Docket No.: 52-011

Southern Nuclear Operating Company
Vogtle Early Site Permit Application
Response to Request for Additional Information Letter No. 10

**Vogle Units 3 and 4
Structural Backfill Evaluation Report**

Response to January 11, 2008 RAI Letter No. 10

Figure 1. Backfill V_s versus Isotropic Confining Pressure (RCTS)

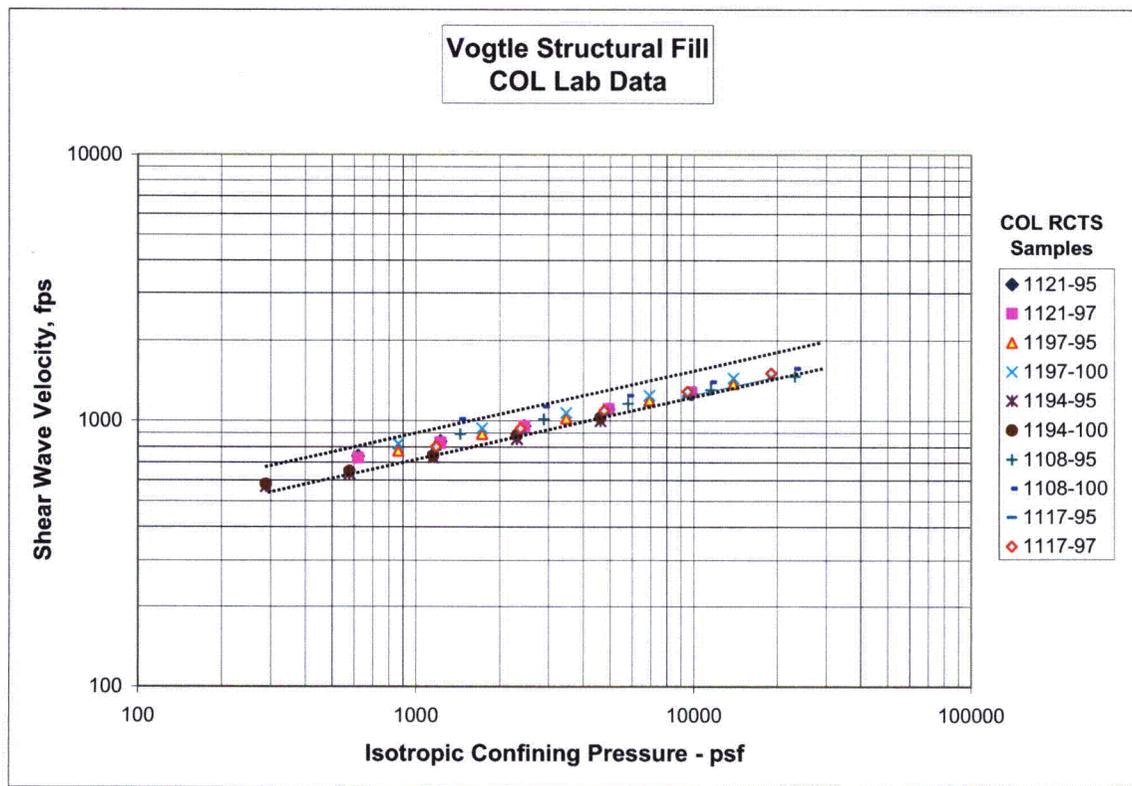
2.5.4-28 From the review of the response to RAIs 2.5.4-14 and 2.5.4-15, it is not clear that the normal variability inherent in the compaction test program (variability of fill grain size distribution, uniformity of water content of compacted soil, etc) will be evaluated sufficiently to capture the variability expected during the production fill program without shear wave velocity testing. In SNC's proposed approach, the wave velocity in its final configuration under the facility and 40 feet of fill to the side will be generated using both analytic approximations for the effects of confinement on in-situ velocity as well as the results from a few RCTS samples of the fill. In-situ wave velocity measurements during production backfill placement are needed for confirmatory purposes to be able to estimate the average velocities of placed soil as well as variability in these velocities under the completed facility. The objective of this confirmatory program is to ensure that in-situ wave velocities in the completed backfill will be equal to or greater than 1,000 fps. SNC is requested to provide additional information and justification of the adequacy of its testing program or a revised testing program.

As expected, of the four parameters discussed above, the confining pressure has the greatest impact on V_s (G_{max}). This result is clearly demonstrated in Figure 1, which shows the relationship between the shear wave velocity and isotropic confining pressure for the backfill materials tested (resonant column and torsional shear [RCTS]) as part of the COL subsurface investigation (MACTEC Appendix G, 2008). The tests were performed on materials that are expected to be used for backfill soils. Fines content ranged from less than 10% to slightly over 25%, the median grain size (D_{50}) was within a very narrow range (~0.2 to 0.3 mm), C_u was on the order of 3 to 4 for the silty sands, and compaction ranged from 95% to approximately 100% of ASTM D1557. Table 1 below summarizes some of the pertinent information from the RCTS test samples.

The laboratory results clearly demonstrate the effect of confining pressure and, just as importantly, show that the variability of computed shear wave velocity with confining pressure, given the materials tested, is relatively small. Further, the results demonstrate that once these materials are compacted in a dense state ($\geq 95\%$ ASTM D1557 [modified proctor]) compacting them to a higher compactive effort does not appreciably affect the shear wave velocity, except for test 1108, which has the highest fines content ($\sim 25\%$). The difference in this case is most likely reflected in a decrease in void ratio. Based on these results we conclude the variation of V_s to be relatively small, given the backfill materials to be used and the proposed compactive effort (ASTM D1557).

FIGURE 2.5.4-23-1 PLANT LAYOUT

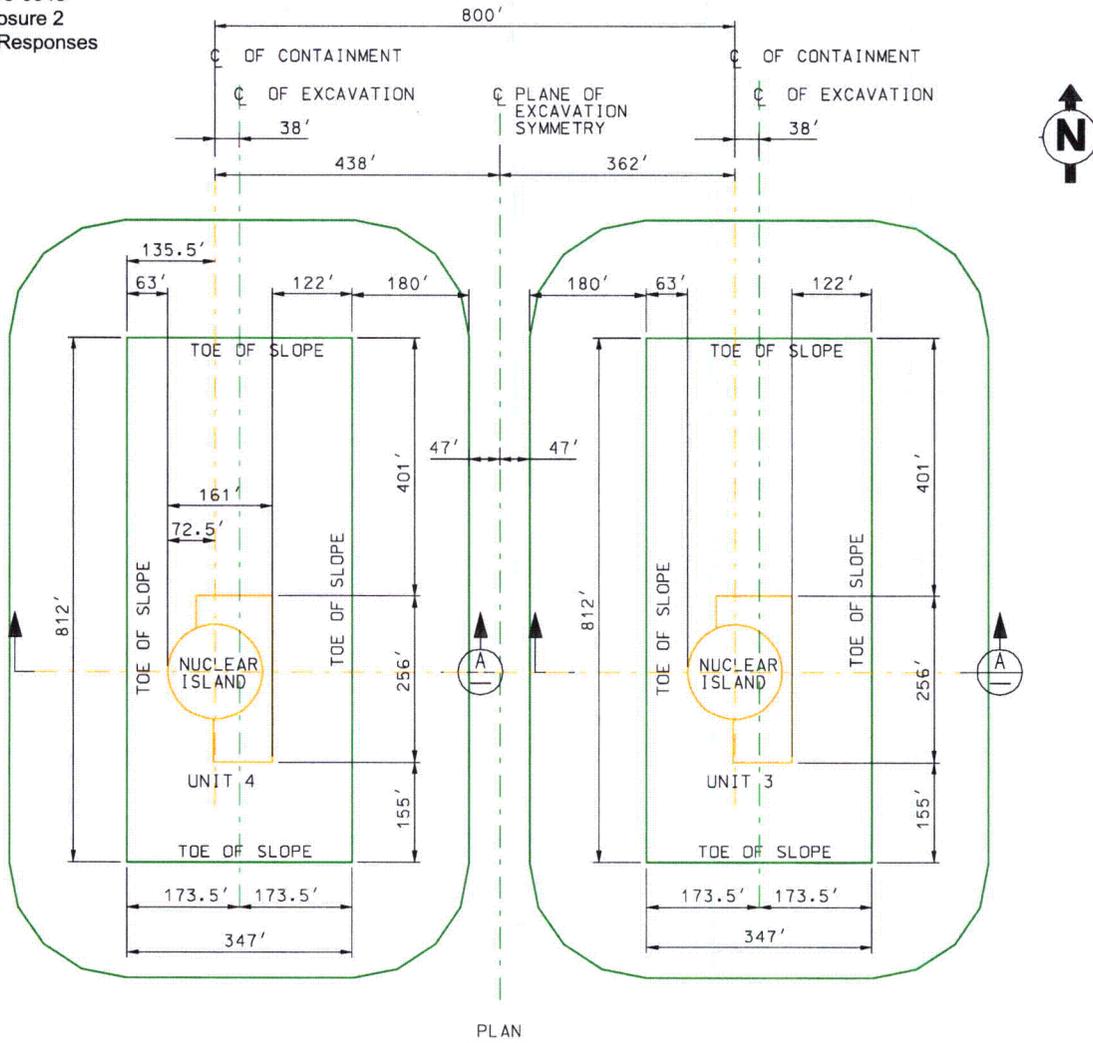
2.5.4-23 The staff found that the response to RAI 2.5.4-4 did not address the concern regarding “the effect of the two-dimensional wave velocity configuration of the excavated zone on site response and soil-structure interaction (SSI) effects.” Additional information should be provided to justify why the effect of the two-dimensional wave velocity consideration was not considered in the SSI analysis.

To provide the information requested, it is currently planned to perform a 2D site response and SSI analysis to evaluate the effect of the extent of backfill on the site response and on the SSI response of the NI. The plant layout is shown in Figure 2.5.4-23-1. For the 2D analysis, the cross section in the East-West direction shown in Figure 2.5.4-23-2 will be used. A plane of symmetry in between the two units will be considered in the analysis so that the extents of backfill for both units are represented in the analysis. The analysis consists of two parts.

FIGURE
RAI 2.5.4-27-1A

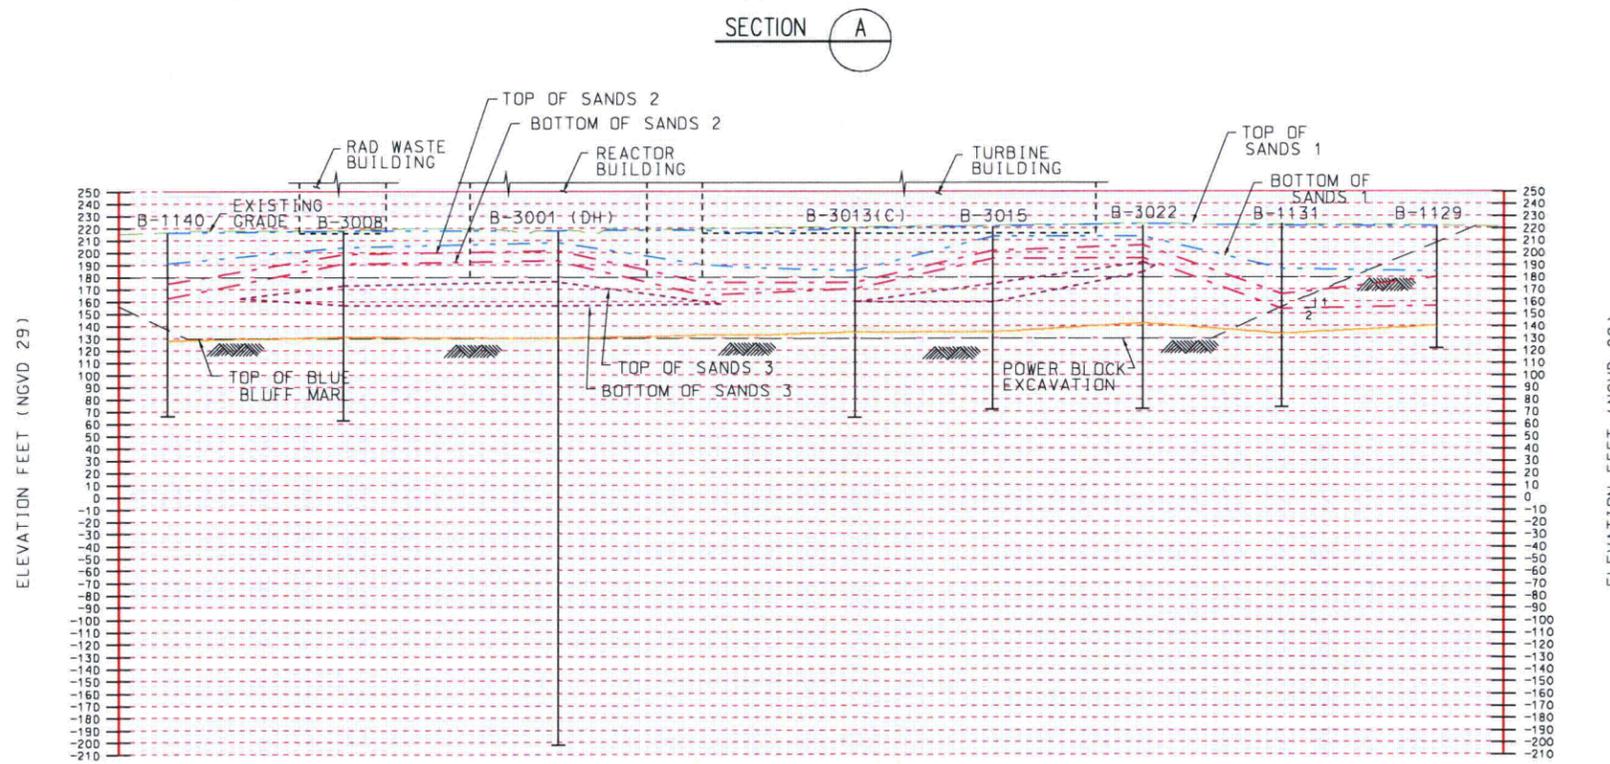
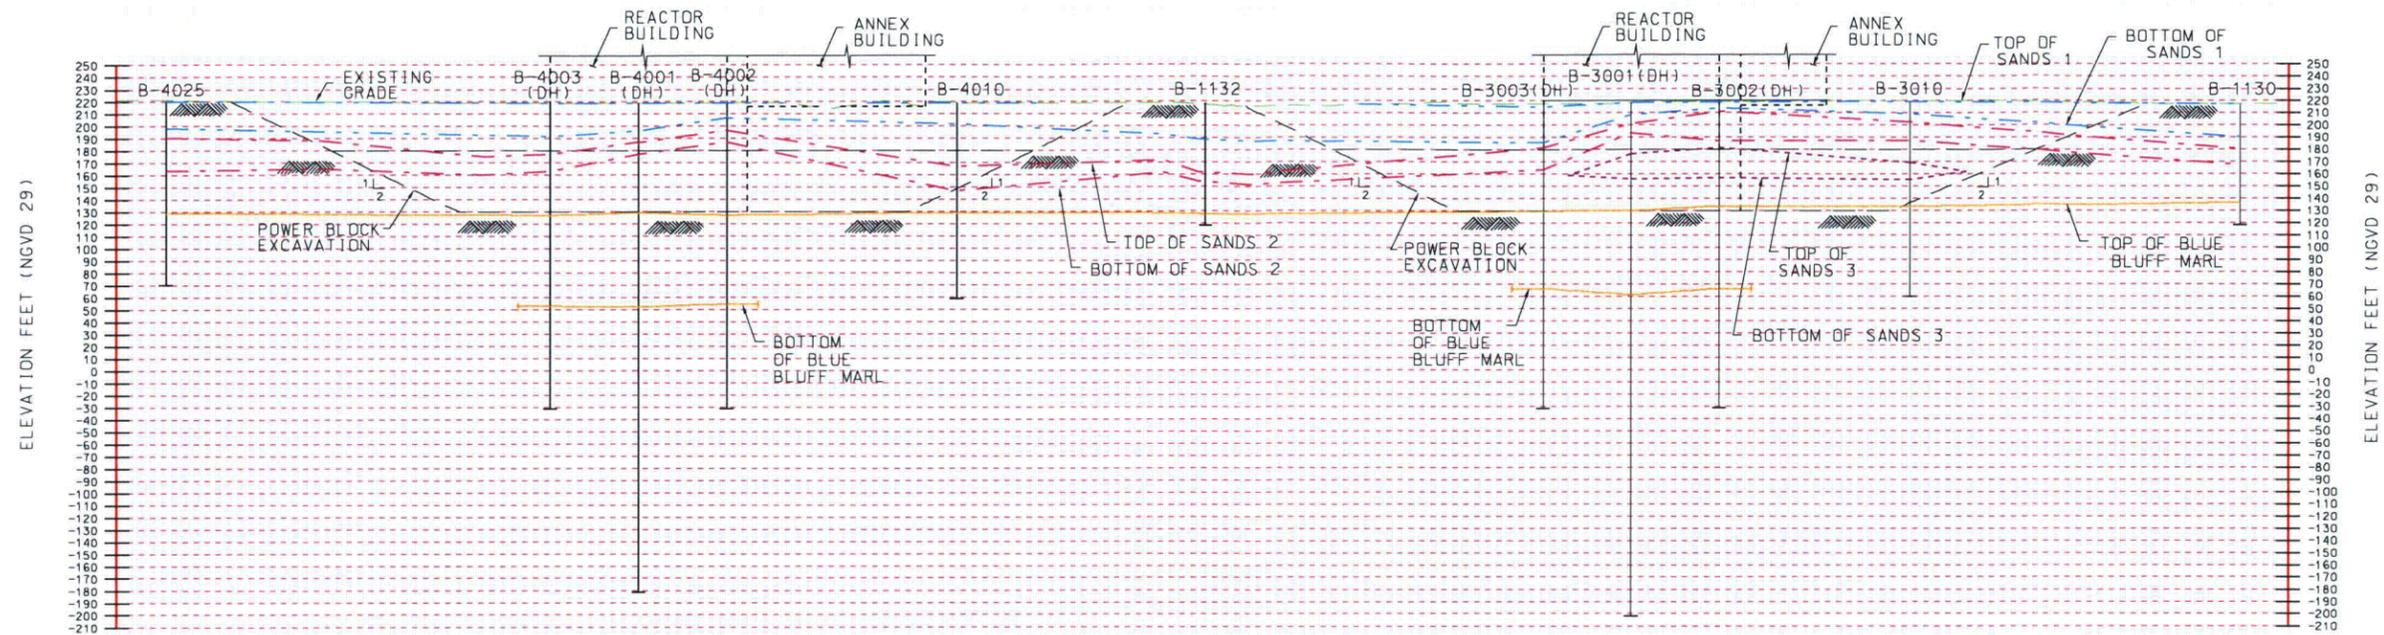
2.5.4-27 In the response to RAI 2.5.4-10, SNC states in part that “Sufficient borrow material ... has been identified and no additional investigations and testing is necessary.” The response further states that “These materials (identified) were classified ... as silty sands (SM), poorly graded sands (SP), and lesser amounts of clayey sands (SC).” The response further describes testing of various material properties and borrow sources, but does not include figures or survey results to justify that sufficient material exists. It is also unclear in the response whether all or just part of the stockpiled material is suitable material. SNC is requested to provide further clarification and justification of the quantity of suitable material in the switchyard area stockpiles. Further, SNC states that approximately 30% of the excavated material from the power block will be salvageable for reuse as structural backfill. However, SNC should provide a description of how the 30% value was determined so the staff can evaluate whether sufficient borrow material exists.

Engineering judgment was used to correlate the layers of suitable borrow material identified in the borings for use in developing 3-D CADD surfaces. The Sands 1, Sands 2, and Sands 3 layers constitute suitable borrow material. The total quantity of this borrow material in the excavation calculated using CADD is approximately 2,000,000 cubic yards, see Figures RAI 2.5.4-27-1a, 1b and 1c.
